NUCLEAR ENERGY INSTITUTE

December 20, 1999

PROJECT NUMBER: 689

Resolution Status of NRC Nov. 3 Comments on Draft NEI 96-07, Rev. 1

Figure 1
10 CFR 50.59 Process

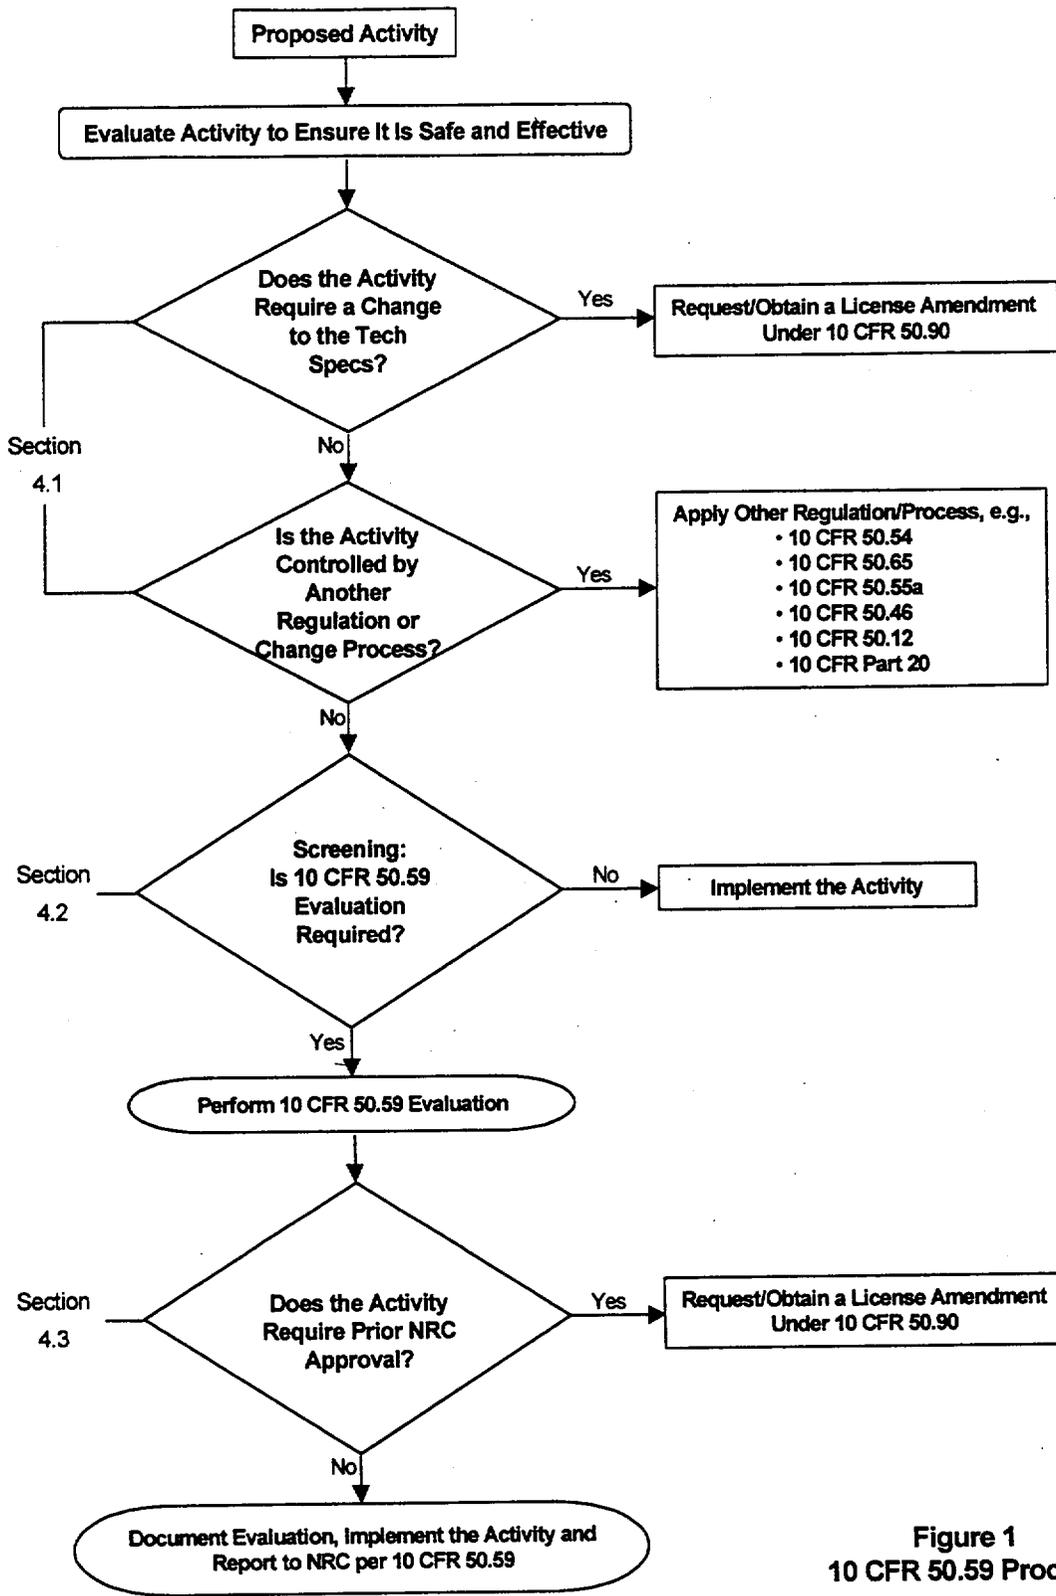
<u>NRC Comment</u>	<u>Resolution</u>
<p>1. The second bullet in Figure 1 on page 4 should be modified to read, "Is the Activity Controlled by Another Regulation or that contains a Change Process?" The rule only allows exclusion when another regulation contains a change process. The ensuing reference to 10 CFR 50.65 also needs to be removed because it does not contain a change process. Conforming changes need to be made in section 4.1.2. Contemplating adding new loads on a safety bus without performing a 50.59 evaluation by considering it maintenance on a bus is not acceptable. Similarly, contemplating new reactor fuel without performing a 50.59 evaluation by considering it maintenance on the core is also not acceptable.</p>	<p>Changed top box of Fig. 1 to say "Proposed Activity" to encompass changes, tests, experiments and maintenance activities. No changes to 2nd decision block or reference to 10 CFR 50.65.</p> <p>Section 4.1.2 modified to clarify the limitations on what can be considered maintenance. Adding new loads on a safety bus or adopting a new fuel design would not be considered maintenance.</p>
